BRIEFING SUMMARY SHEET

DEVELOPMENT ASSESSMENT CASE NUMBER: CD-2018-0008 – Austin Green

Presentation of a Project Assessment Report for the Austin Green Planned Unit Development, located at 11600-12337 Harold Green Road, within the Colorado River Watershed and the Elm Creek Watershed.

MASTER REVIEW REPORT

2-LANE MINOR ARTERIAL WITH SHARED USE PATH

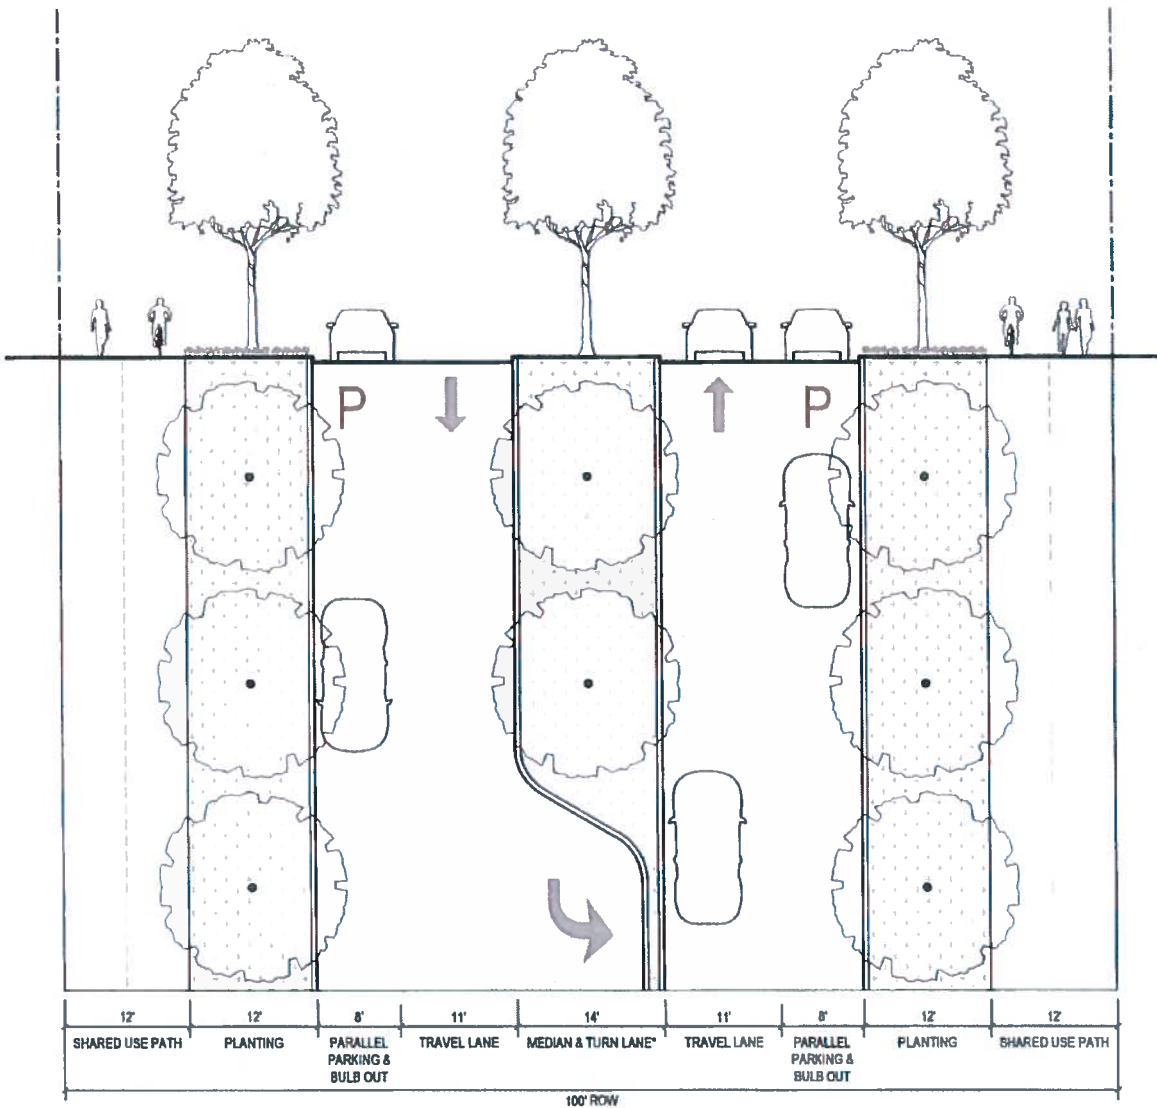
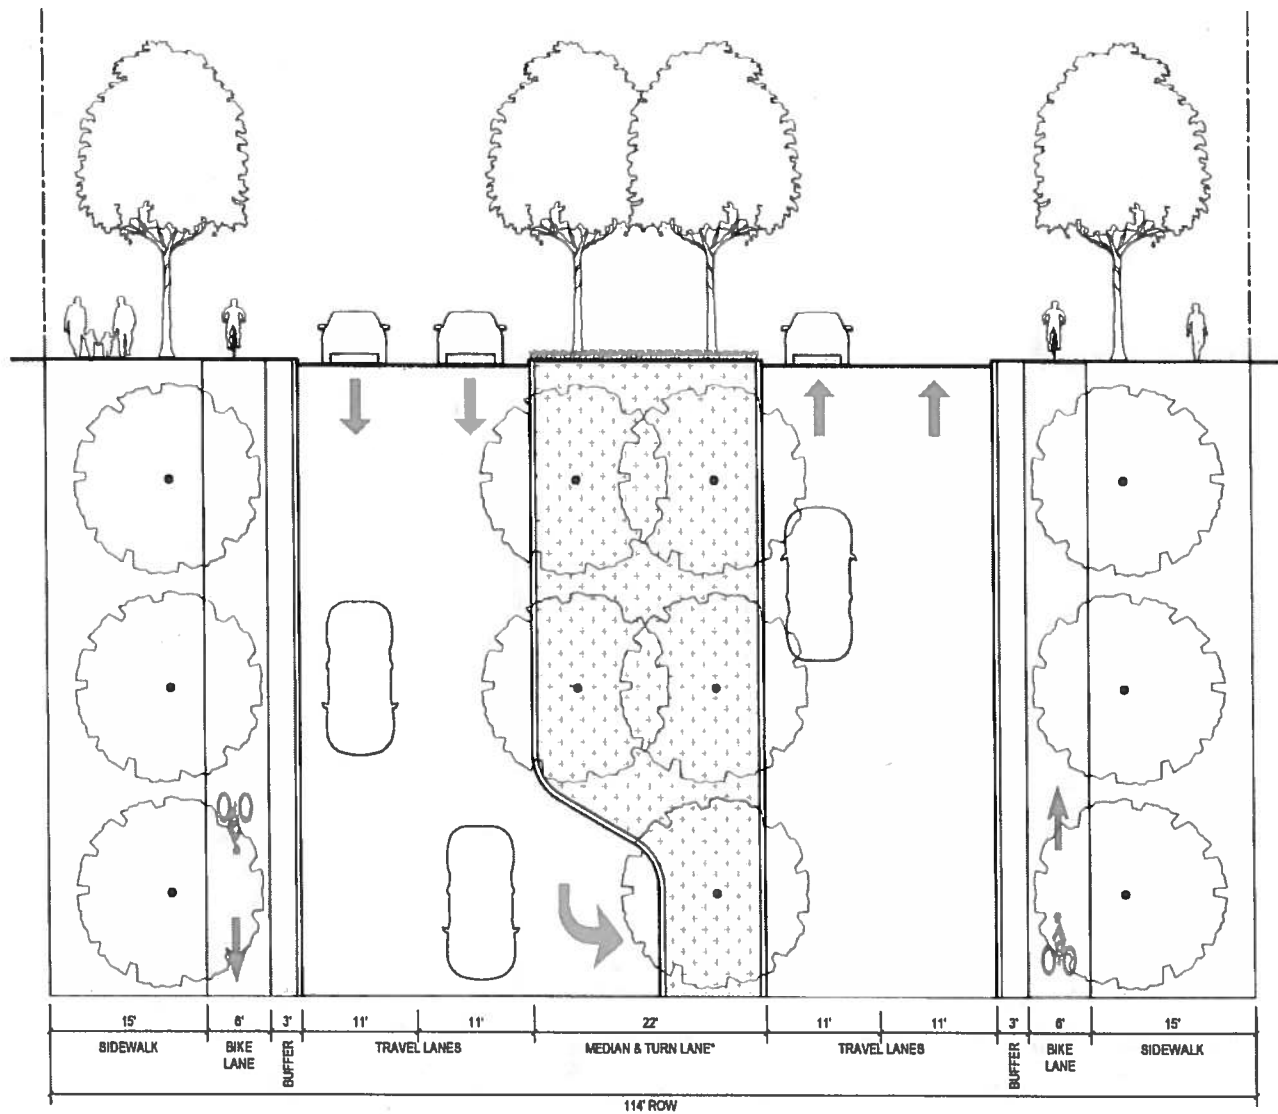
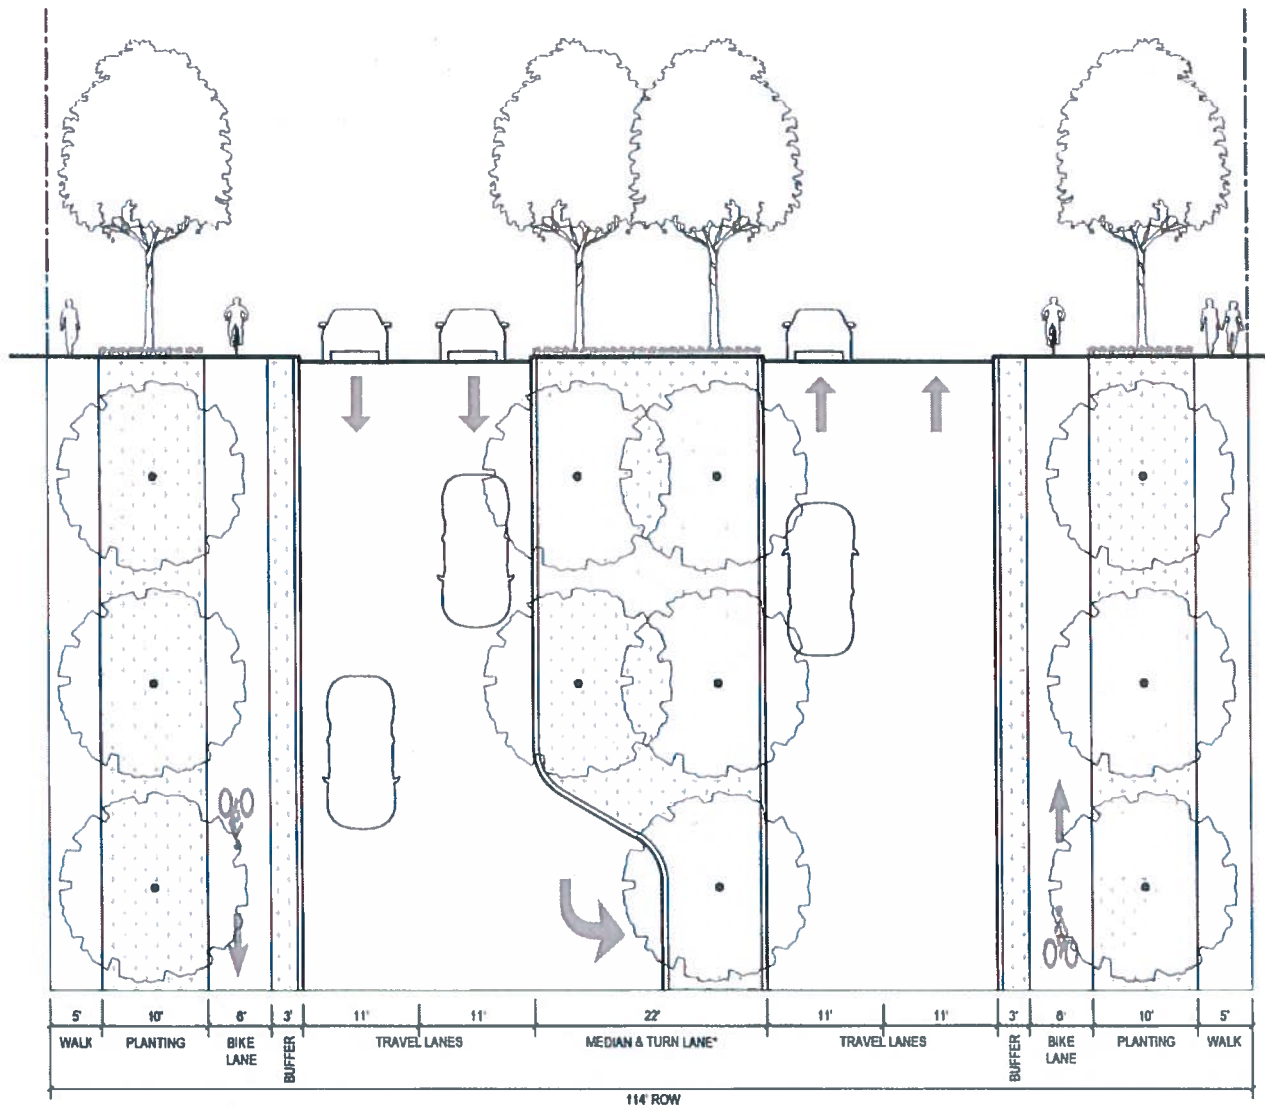
1. Please schedule a meeting with this reviewer and the Fire Marshal. Many of the proposed street sections do not comply with the Fire Code for access and/or operational area. Only the Fire Marshal has the authority to allow modification to the adopted Fire Code. Private roads shall be minimum of 25 feet wide void of parked vehicles. One way private roads providing fire access shall be a minimum 15 feet wide void of parked vehicles. Unless adjacent to buildings, the private road shall be a minimum 25 feet wide void of parked vehicles, landscaping and landscape furniture.
2. Fire protection is a Tier One activity per the City's PUD ordinance. Any deviation from the adopted Fire Code must be explicitly written in the development's PUD zoning ordinance or related exhibits.
3. Please identify any industrial activities within 1000 feet of the project area with zoning plan.
